3-2 Part Throttle Downshift Flare

Bulletin No.: 67-71-47

3-2 Part Throttle Downshift Flare (Replace 3-2 Solenoid)

Figure 1 - Hydra-Matic 4L60-E Transmission Identification Information

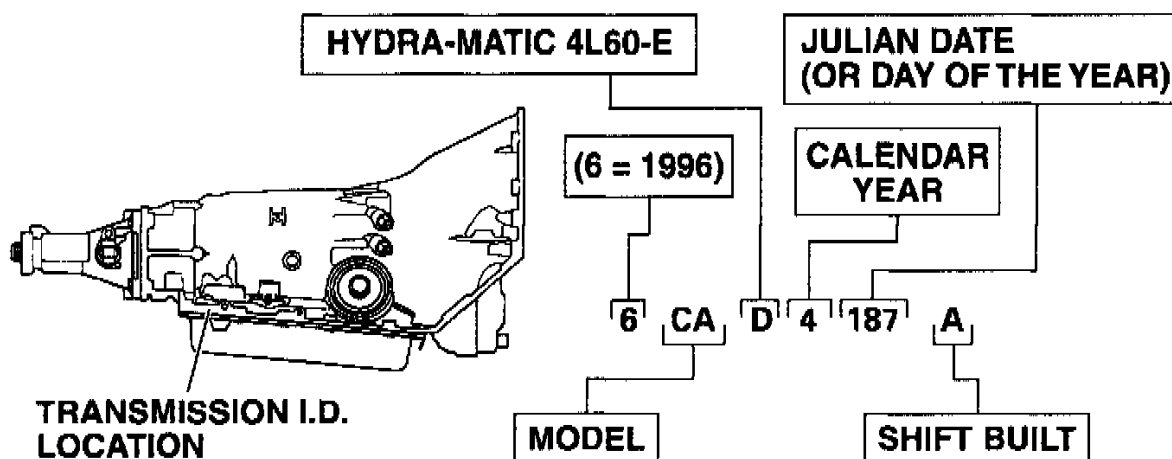
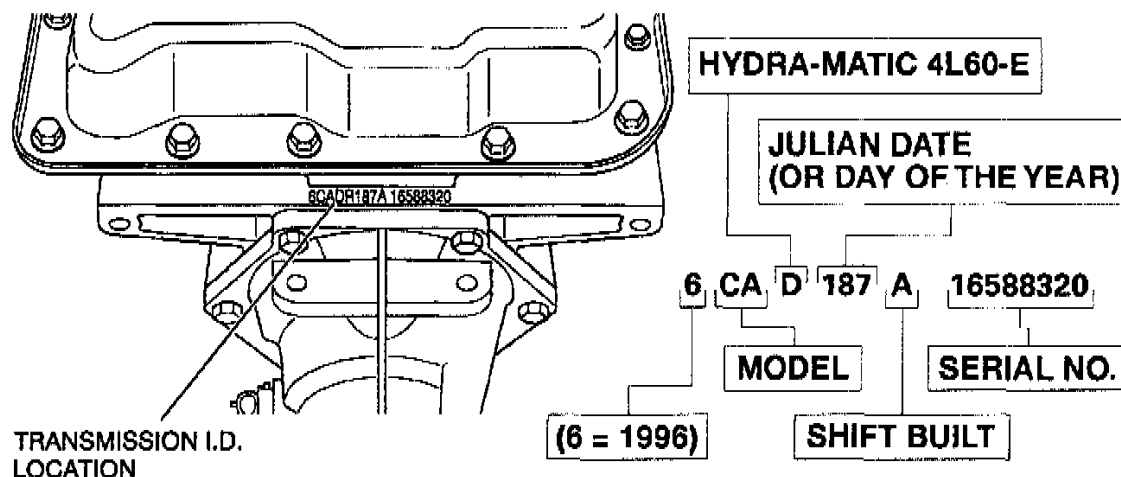
Condition (Figures 1 and 2)

Some owners of the above models with a HYDRA-MATIC 4L60-E transmission (built before May 24, 1996/Julian Date 6145) may experience an engine speed flare of 1000-2000 RPM, during a part throttle downshift at 19-31 mph. This condition will not set any DTC's (Diagnostic Trouble Codes).

Figure 3 - Location and Identification of the 3-2 Control Solenoid on the Control Valve Body

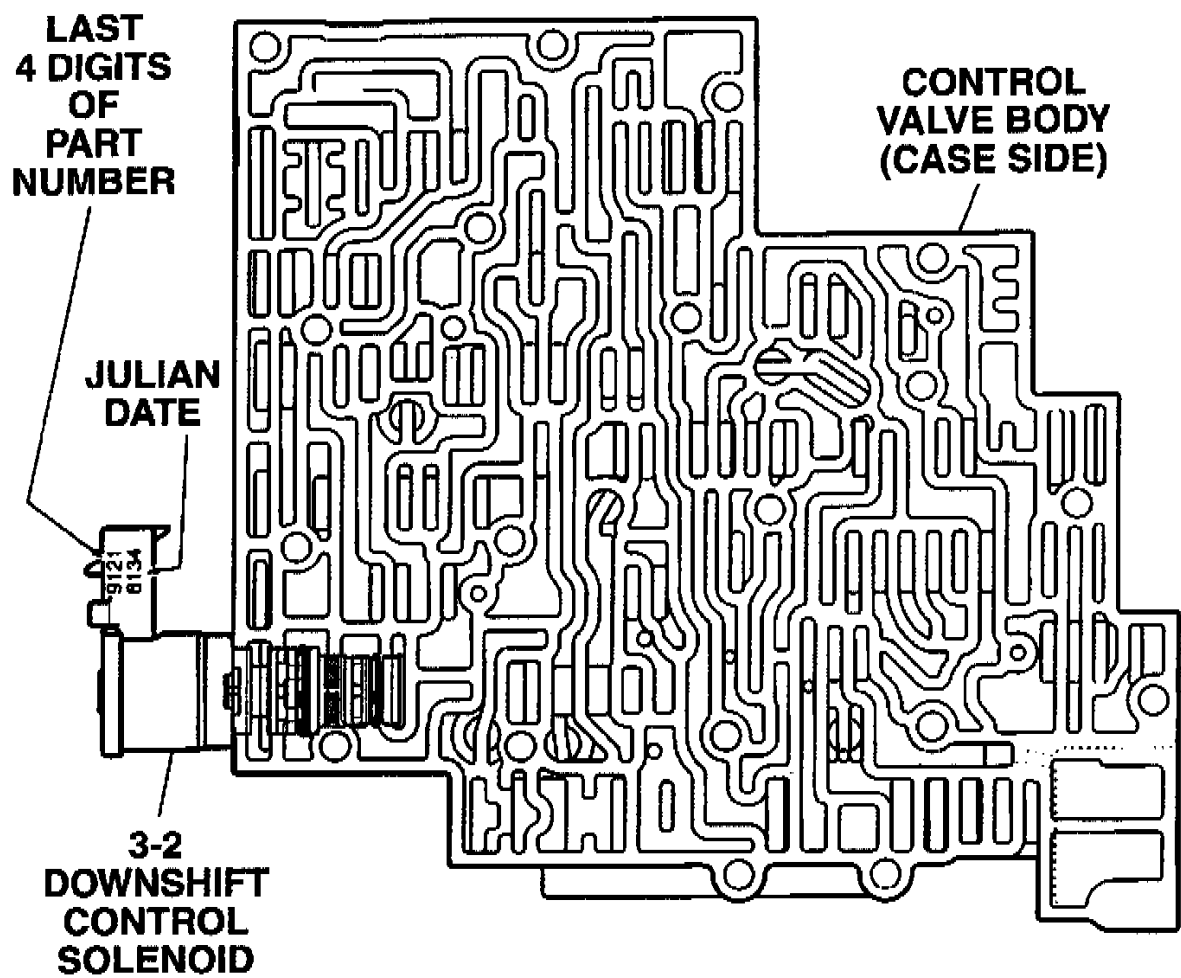
Exhaust seat on the 3-2 control solenoid backing out.

Correction (Figure 3)

Replace the 3-2 control solenoid. Julian Date on the solenoid will be May 13, 1996 (6134) or later.
